ALERT SERVICE BULLETIN

REPLACEMENT OF FUEL PUMP

FOR ROTAX® ENGINE TYPE 912 (SERIES) ASB-912-053UL

Replacement of fuel pumps with part no. 892230, 892232, 892540 through part no. 892542 and Replacement of fuel pumps with part no. 892235, 892236, 892545 through part no. 892546 for ROTAX[®] engine type 912 (Series).

(see Fig.1)

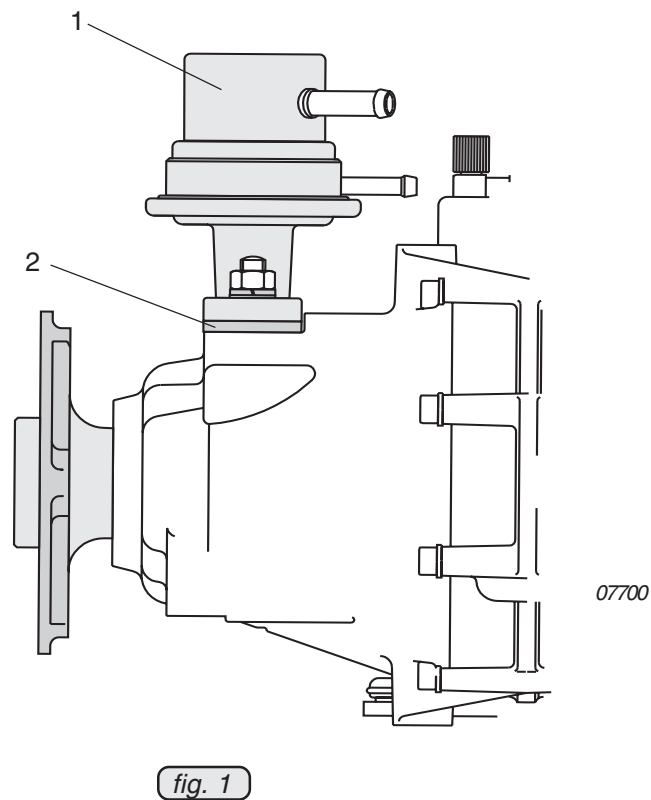
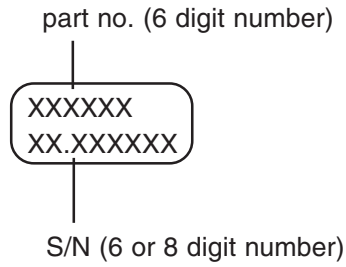
1. Remove fuel pump (1).
2. Gasket (2) replaced by new part.

■ **CAUTION:** Install new gasket supplied with new fuel pump. The thickness is different.

3. Install fuel pump. Tightening torque 15 Nm (133 in.lb).
4. Install fuel line.
